PLANNING

TITLE
SIDMOUTH STREET,
CAMDEN

GROUND FLOOR PLAN

Drawing No: 12.036.151

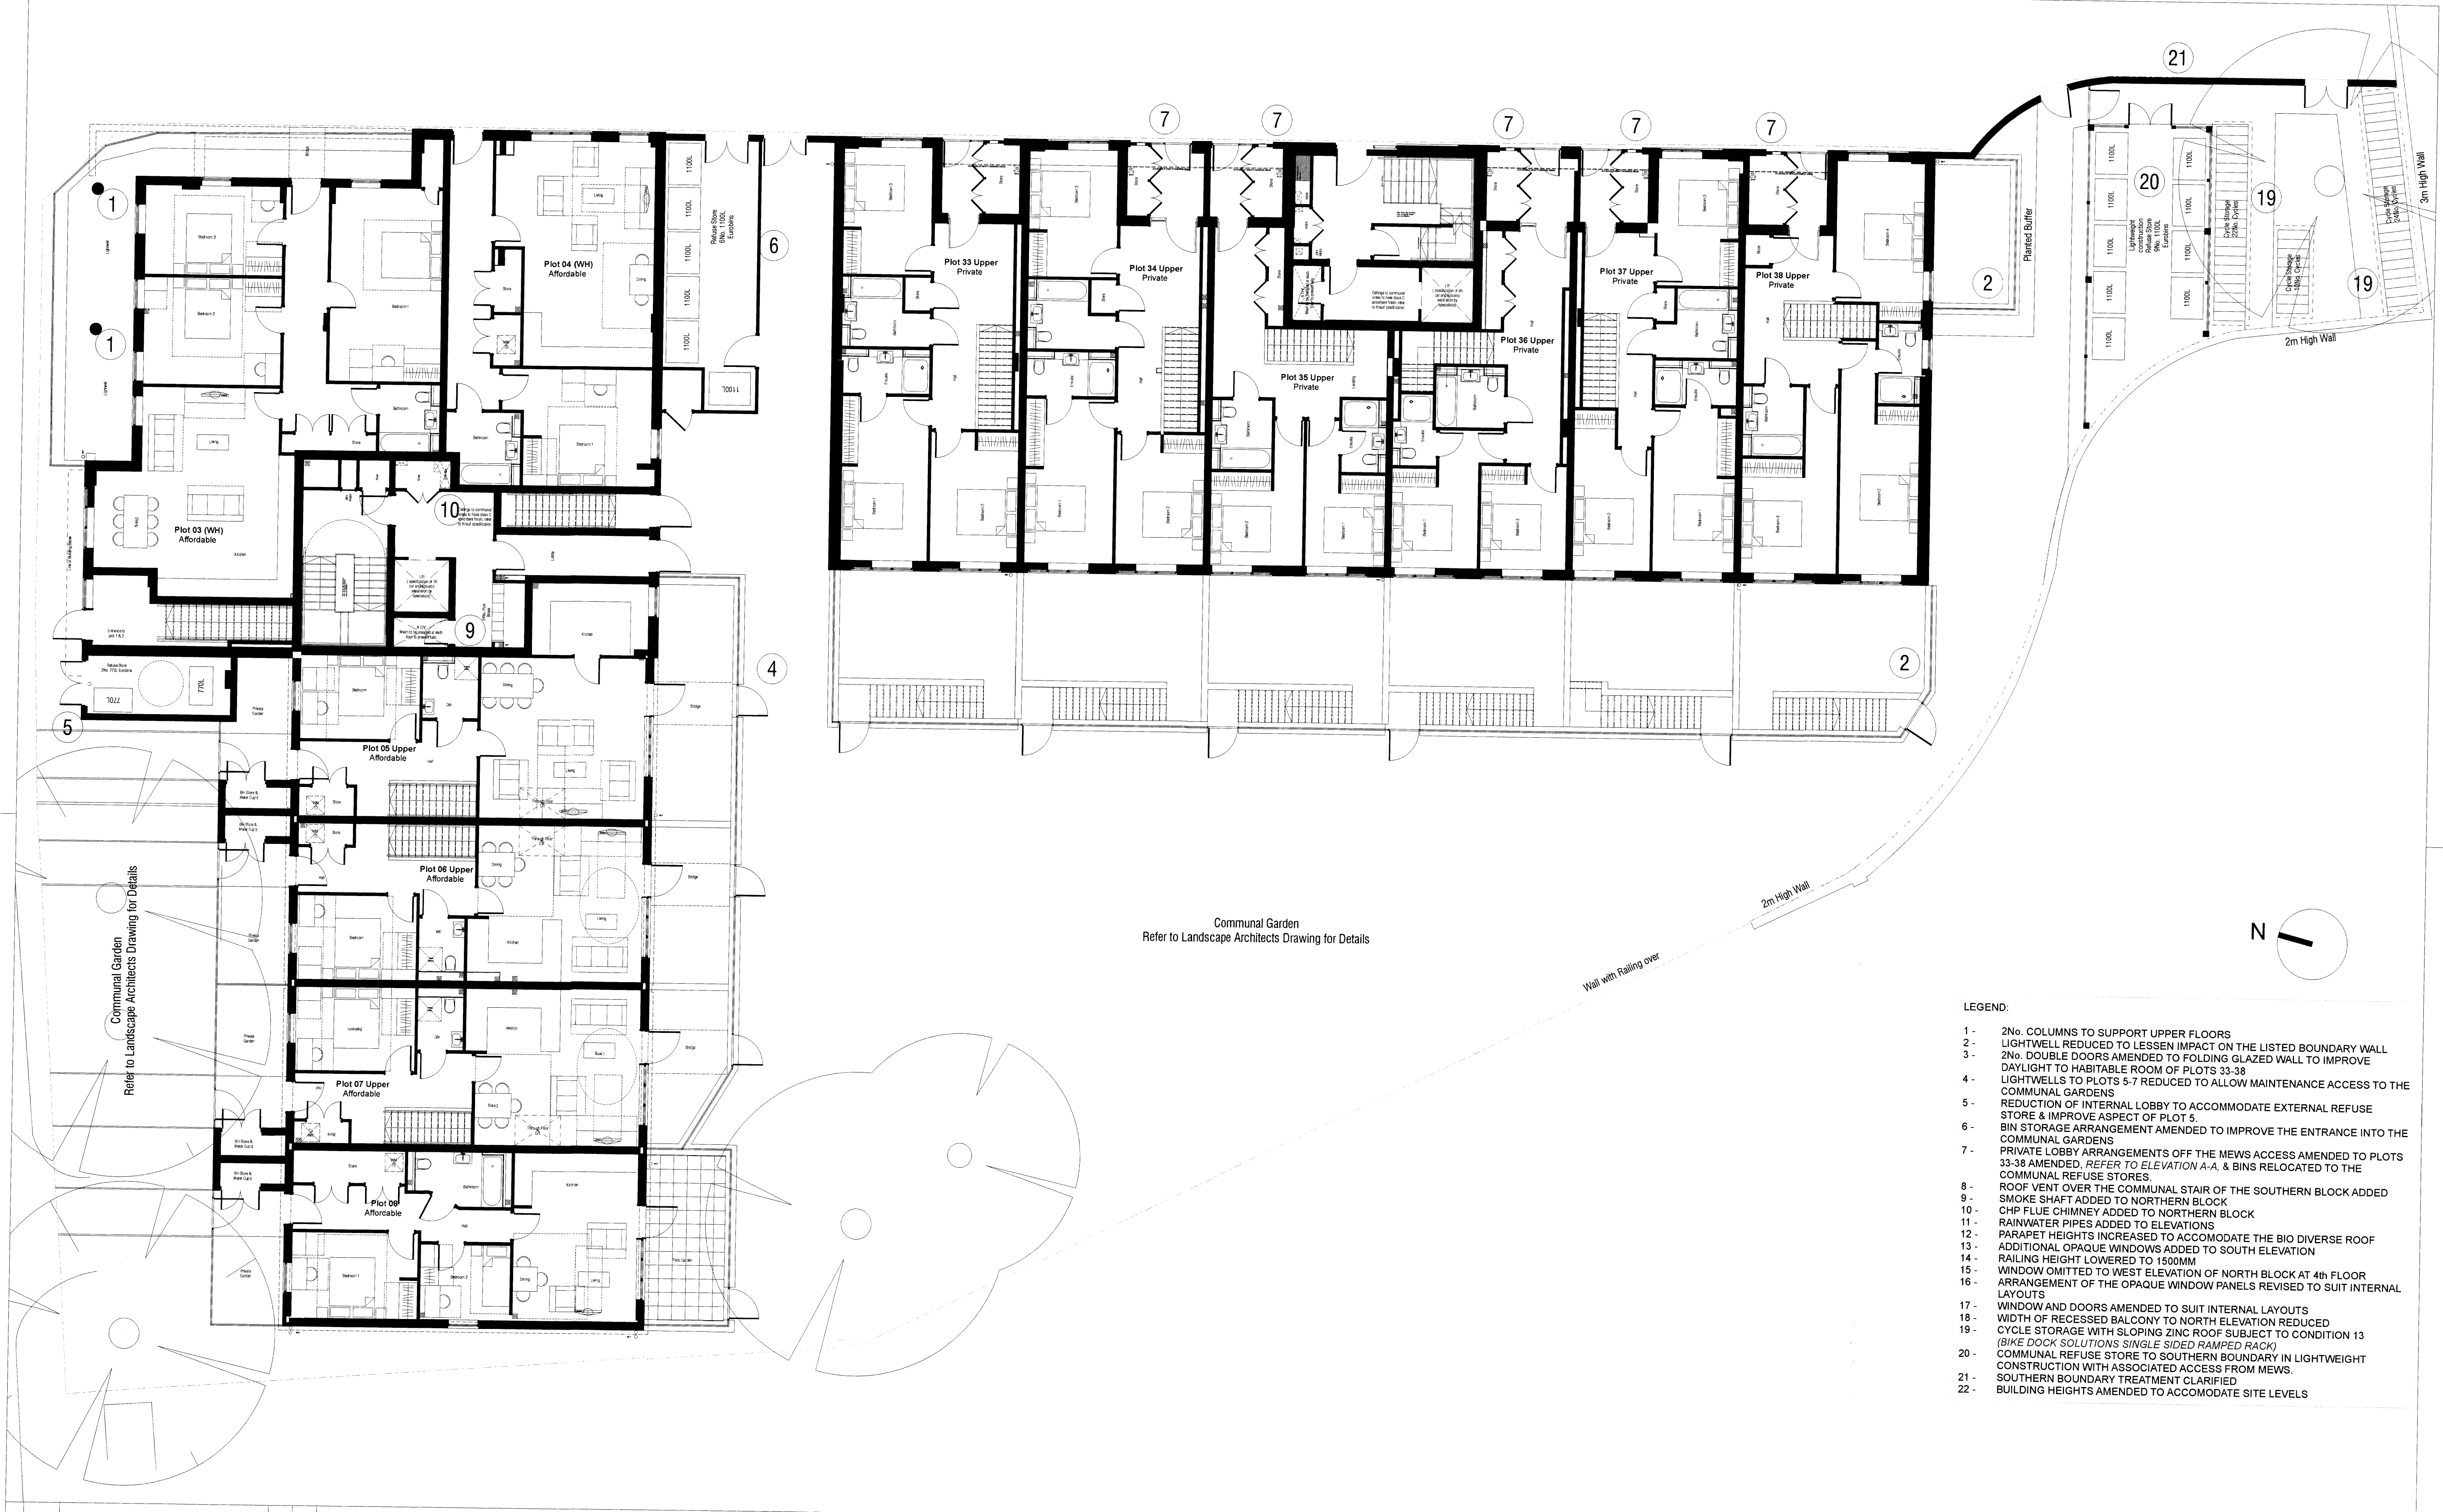
- LEGEND:
- 1 - 2No. COLUMNS TO SUPPORT UPPER FLOORS
 - 2 - LIGHTWELL REDUCED TO LESSEN IMPACT ON THE LISTED BOUNDARY WALL
 - 3 - 2No. DOUBLE DOORS AMENDED TO FOLDING GLAZED WALL TO IMPROVE DAYLIGHT TO HABITABLE ROOM OF PLOTS 33-38

- 4 - LIGHTWELLS TO PLOTS 5-7 REDUCED TO ALLOW MAINTENANCE ACCESS TO THE COMMUNAL GARDENS
 - 5 - REDUCTION OF INTERNAL LOBBY TO ACCOMMODATE EXTERNAL REFUSE STORE & IMPROVE ASPECT OF PLOT 5

- 6 - BIN STORAGE ARRANGEMENT AMENDED TO IMPROVE THE ENTRANCE INTO THE COMMUNAL GARDENS
 - 7 - PRIVATE LOBBY ARRANGEMENTS OFF THE MEWS ACCESS AMENDED TO PLOTS 33-38 AMENDED, REFER TO ELEVATION A-A, & BINS RELOCATED TO THE COMMUNAL REFUSE STORES.

- 8 - ROOF VENT OVER THE COMMUNAL STAIR OF THE SOUTHERN BLOCK ADDED
 - 9 - SMOKE SHAFT ADDED TO NORTHERN BLOCK
 - 10 - CHP FLUE CHIMNEY ADDED TO NORTHERN BLOCK

- 11 - RAINWATER PIPES ADDED TO ELEVATIONS
 - 12 - PARAPET HEIGHTS INCREASED TO ACCOMMODATE THE BIO DIVERSE ROOF
 - 13 - ADDITIONAL OPAQUE WINDOWS ADDED TO SOUTH ELEVATION

- 14 - RAILING HEIGHT LOWERED TO 1500MM
 - 15 - WINDOW OMITTED TO WEST ELEVATION OF NORTH BLOCK AT 4th FLOOR
 - 16 - ARRANGEMENT OF THE OPAQUE WINDOW PANELS REVISED TO SUIT INTERNAL LAYOUTS

- 17 - WINDOW AND DOORS AMENDED TO SUIT INTERNAL LAYOUTS
 - 18 - WIDTH OF RECESSED BALCONY TO NORTH ELEVATION REDUCED
 - 19 - CYCLE STORAGE WITH SLOPING ZINC ROOF SUBJECT TO CONDITION 13 (BIKE DOCK SOLUTIONS SINGLE SIDED RAMPED RACK)

- 20 - COMMUNAL REFUSE STORE TO SOUTHERN BOUNDARY IN LIGHTWEIGHT CONSTRUCTION WITH ASSOCIATED ACCESS FROM MEWS.
 - 21 - SOUTHERN BOUNDARY TREATMENT CLARIFIED

- 22 - BUILDING HEIGHTS AMENDED TO ACCOMMODATE SITE LEVELS

REVISIONS		
Rev	Date	Description
C	24/07/2012	CHP GAS METER ADDED
B	24/07/2012	REFUSE STORE TO SOUTHERN BOUNDARY AMENDED
A	19.07.12	LEGEND OF AMENDMENTS REVISED & REFERENCES AMENDED TO SUIT
